APOLLO MISSION TECHNIQUES

MISSION J-2 AND MISSION J-3
UPDATE

TECHNIQUES DESCRIPTION

SUPERSEDES
APOLLO MISSION TECHNIQUES
MISSION J-1 UPDATE
MSC-04278
May 26, 1971

Figure 5-1. LM Activation to PDI Timeline

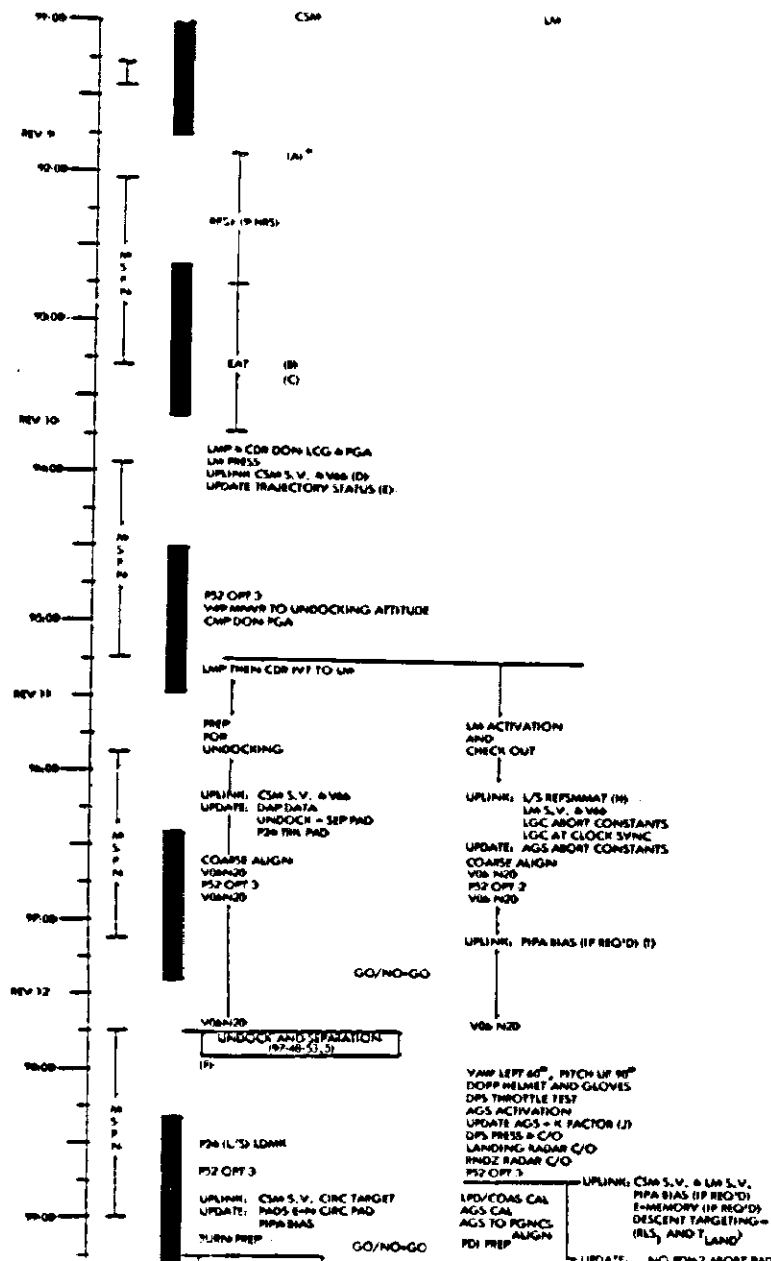
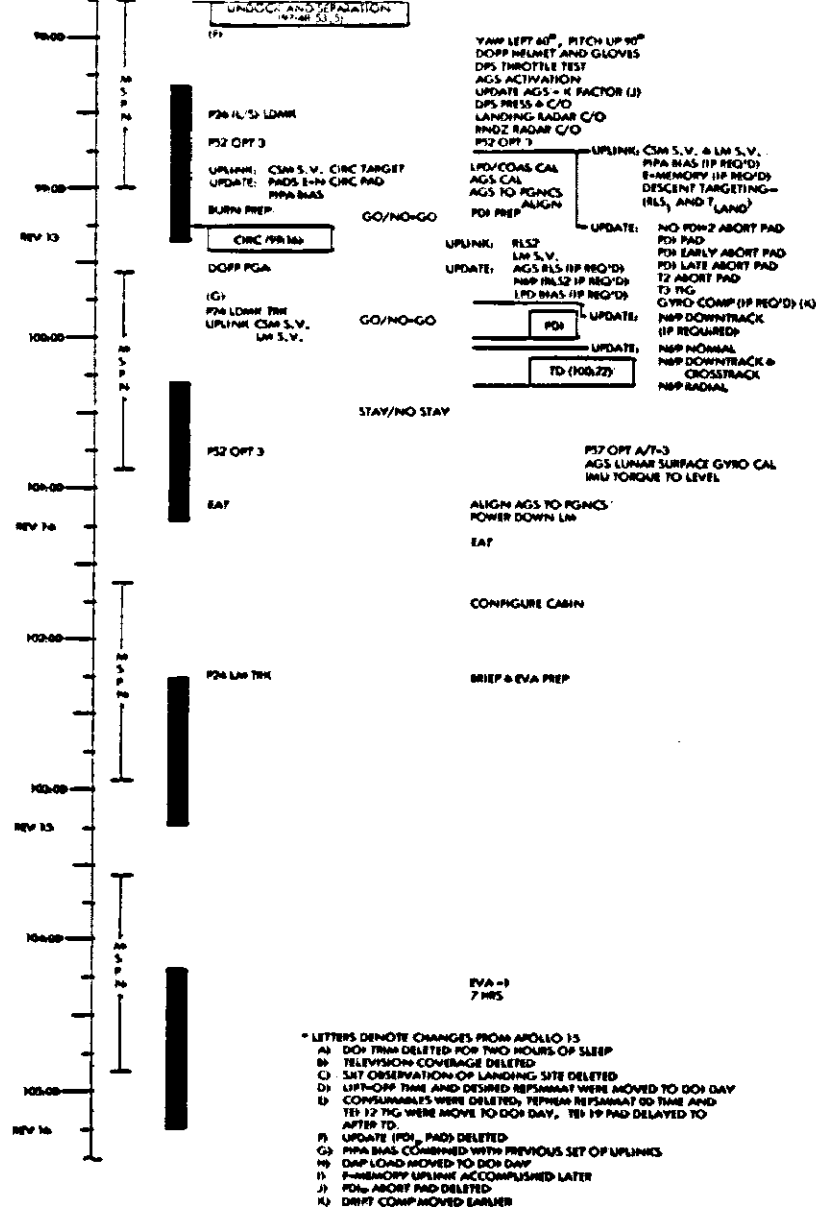
The pre-PDI LM activation timeline has been shortened (Figure 5-1) to increase post-touchdown EVA time on the lunar surface. This shortened sequence results in a lunar landing on revolution 13 rather than 14. The deleted revolution was the one which contained the high orbit landmark tracking and results in PDI being just one-half revolution after CIRC. This phasing change causes major revisions in the descent abort profiles (Section 7.1). Landmark tracking is not required for landing because the landing site errors (for Apollo 16) are not large enough to present a crew safety problem. This could change for Apollo 17, depending on the final site selection. Additional relaxation of the pre-PDI timeline was obtained by deleting the television coverage, certain updates, and the DOI TRIM. (If a DOI TRIM is required, the crew will wake up 2 hours earlier to accomplish the maneuver.) Also, several updates and uplinks are moved or combined when compared with the baseline timeline.

The docked P52 and the P52 just after undocking (Figure 5-1) should be accomplished on time to provide adequate time between the P52's to get a drift check; MCC-II has to compute and update the drift compensation (if required) before LOS in revolution 12. This means that DPS, RR, and LR checkout can be slipped until after the second P52, if required. An unacceptable drift check could result from a bad first P52, (e.g., larger torque angles than expected). To avoid this contingency, three V06N20's are scheduled. (This verb/noun combination yields a decimal display of present ICDU angles.) The sequence is

Figure 5-2. LM Jettison Timeline

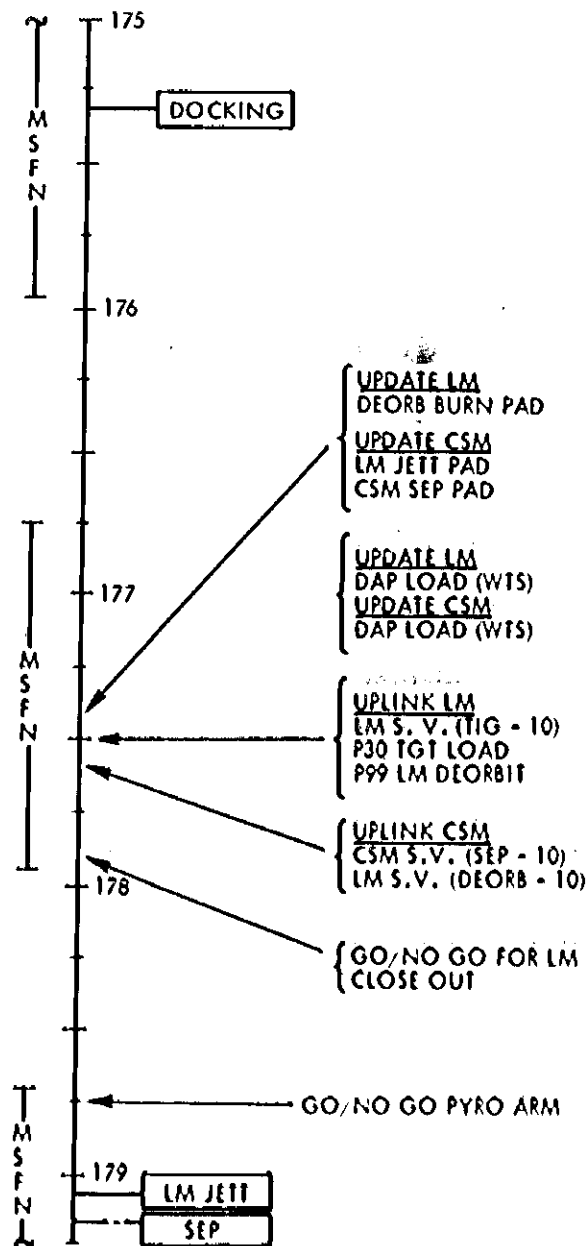
The LM jettison timeline (Figure 5-2) and procedures are essentially the same as to those given in the baseline document with exception of the separation (SEP) maneuver and the time of the uplink of the deorbit PAD's. The CSM SEP maneuver (P30) is now 2 feet per second postgrade (Apollo 15 used 1 foot per second retrograde) and is executed 5 minutes after LM jettison. This allows SEP to be slipped and protects against a larger LM ΔV resulting from higher than nominal tunnel pressure. The uplink of the deorbit PAD's are more to the end of the equipment transfer period (revolution 53), i.e., closer to the deorbit maneuver to improve targeting.
